# TM 11-6625-274-35

TEST SETS, ELECTRON TUBE TV-7/U,  
TV-7A/U, TV-7B/U, AND TV-7D/U

TM 11-6625-274-35  
C 5

**Direct Support, General Support, and Depot Maintenance Manual  
TEST SETS, ELECTRON TUBE TV-7/U,  
TV-7A/U, TV-7B/U, AND TV-7D/U**

Figure 38. Voltage tests.

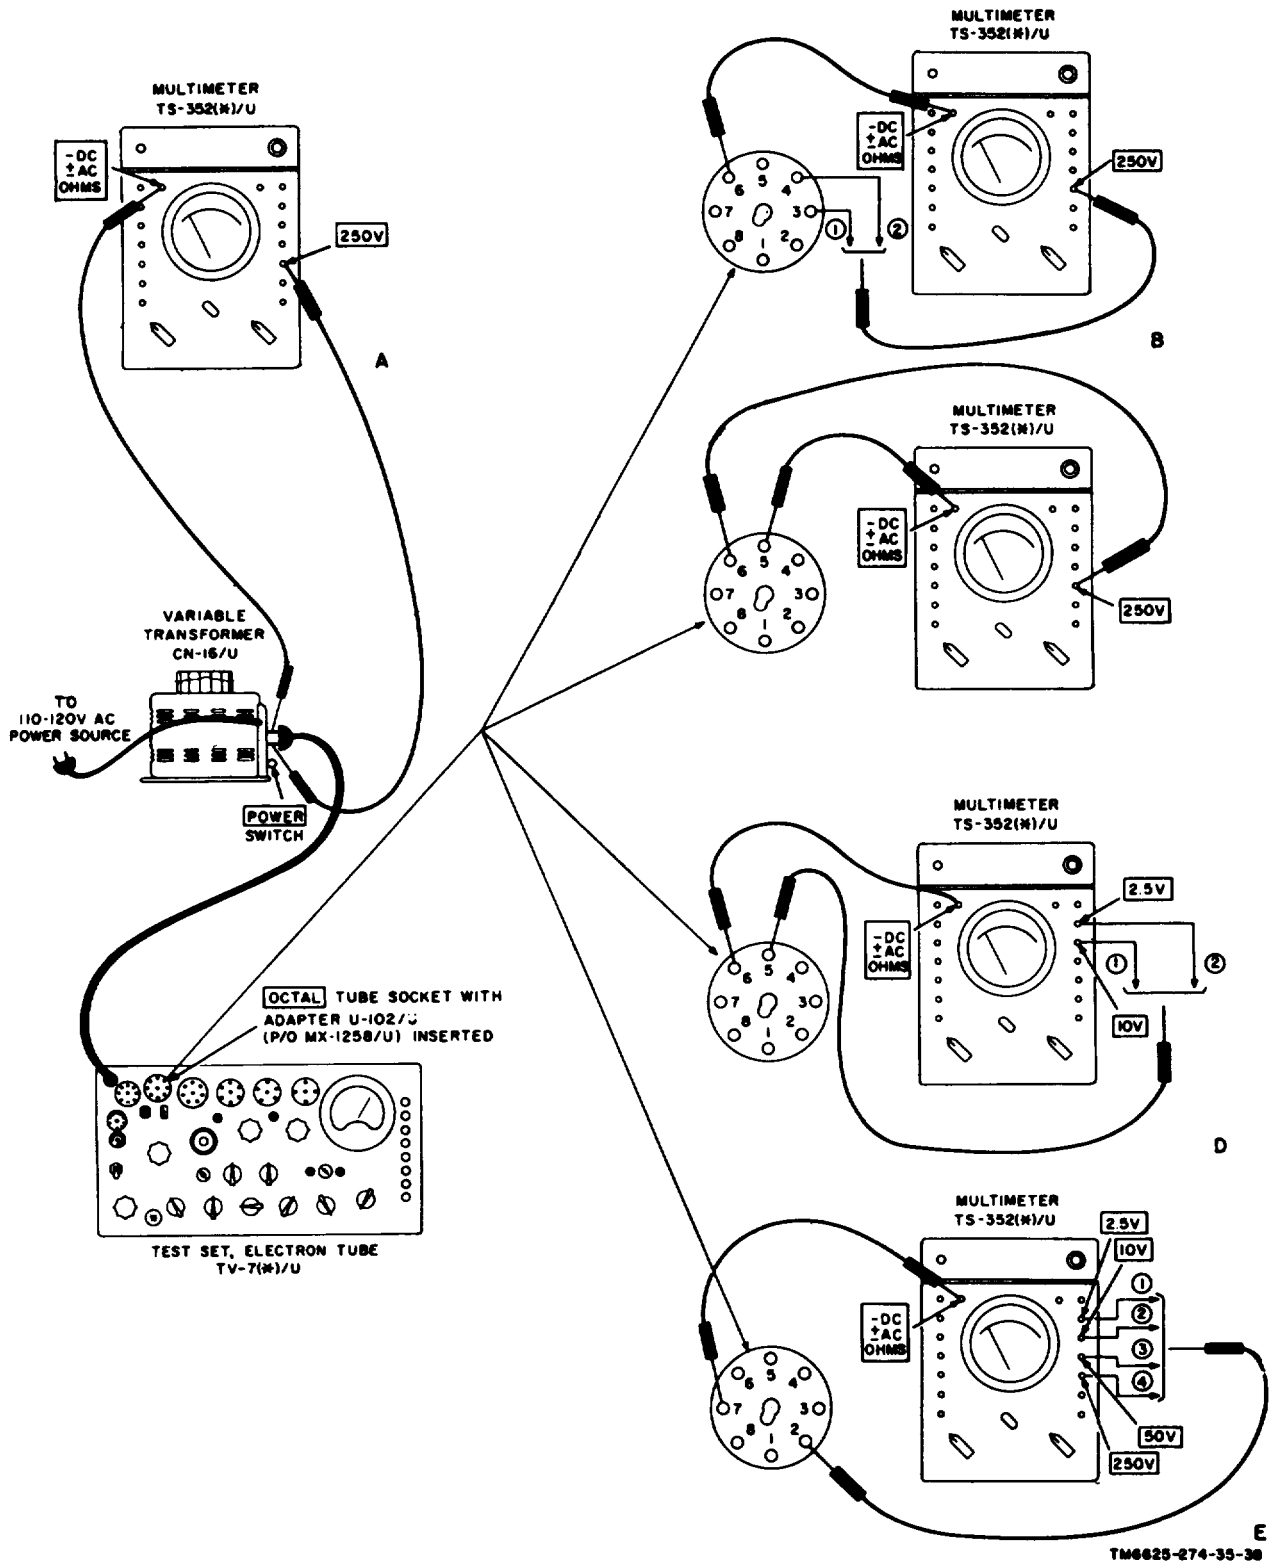
Page 49, paragraph 36c, chart, performance standard column. Make the following changes:

Step 2b. Change "150 volts  $\pm 3$ " to read "150 volts  $\pm 6$ ."

Step 2d. Change "130 volts  $\pm 3$ " to read "130 volts  $\pm 6$ ."

Step 4, Performance standard column:

b(4). Change "0.65 to 0.72" to read "0.62 to 0.75."

c(4). Change "1.06 to 1.16" to read "1.00 to 1.22."

d(4). Change "1.26 to 1.42" to read "1.21 to 1.47."

e(4). Change "1.90 to 2.10" to read "1.80 to 2.20."

g(4). Change "2.58 to 2.85" to read "2.45 to 2.99."

h.(4). Change "3.25 to 3.60" to read "3.09 to 3.77."

i(4). Change "4.30 to 4.75" to read "4.08 to 4.98."

j(4). Change "5.15 to 5.68" to read "4.88 to 5.96."

k(4). Change "6.2 to 6.8" to read "5.85 to 7.15."

l(4). Change "7.32 to 8.1" to read "6.94 to 8.48."

n(4). Change "9.6 to 10.8" to read "9.18 to 11.22."

o(4). Change "12.1 to 13.3" to read "11.4 to 14.0."

p(4). Change "19 to 21" to read "18.0 to 22.0."

q(4). Change "25.3 to 28" to read "24.0 to 29.4."

r(4). Change "35.2 to 39" to read "33.4 to 40.8."

t(4). Change "51.5 to 57" to read "48.9 to 59.7."

u(4). Change "74 to 82" to read "70.2 to 85.8."

v(4). Change "115 to 127" to read "108.9 to 133.1."

Figure 44(2). Test Set, Electron Tub TV-7D, schematic diagram (sheet 2).

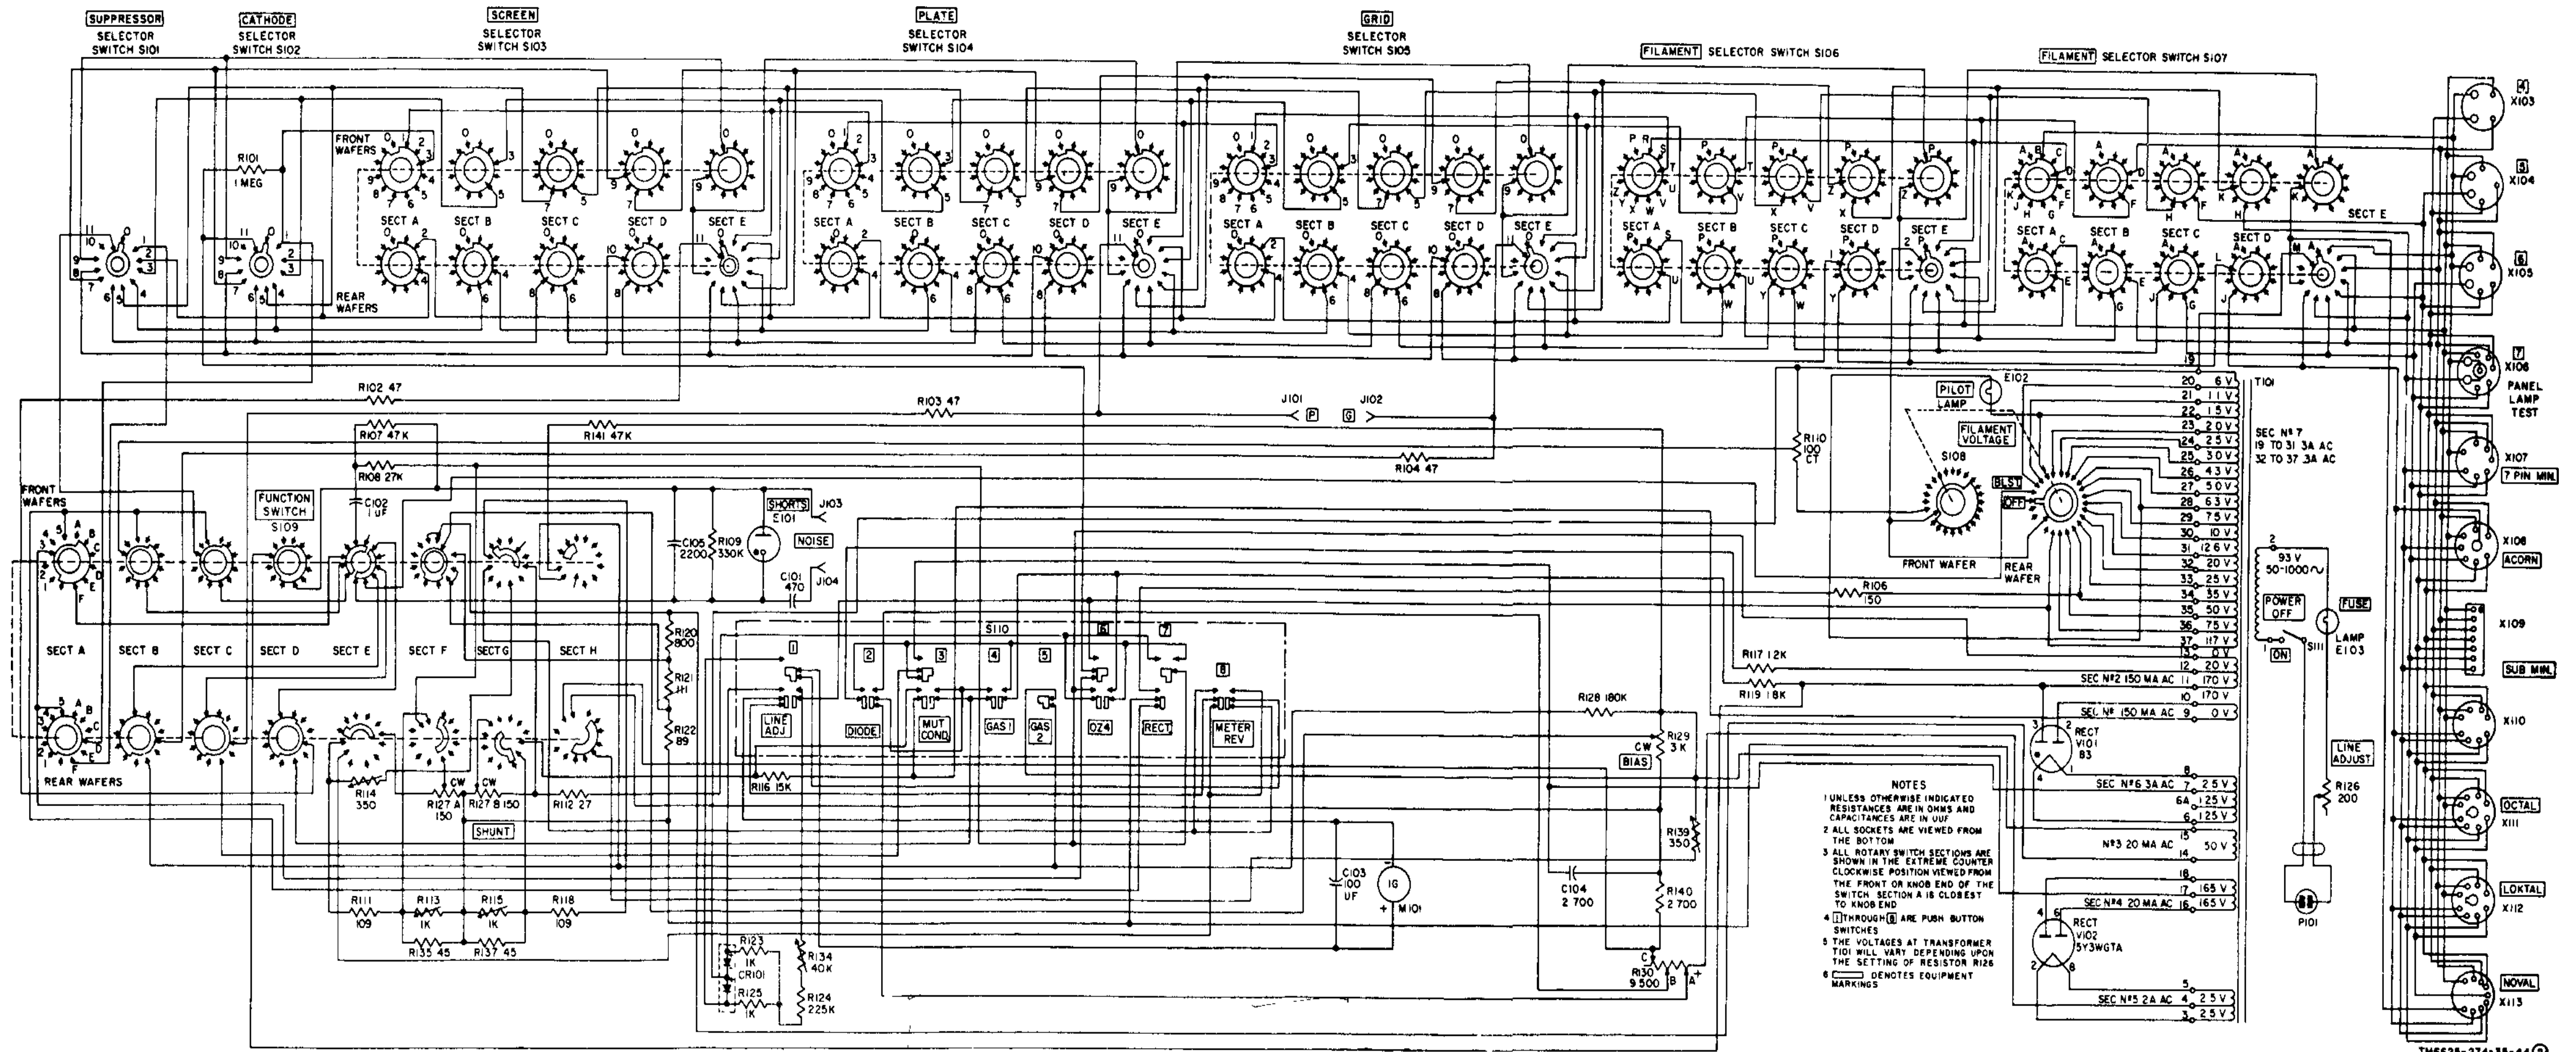
Figure 44② (sheet 2), switch S109, section F. Delete the connection between contacts D and E and substitute 2 connections between C and E.
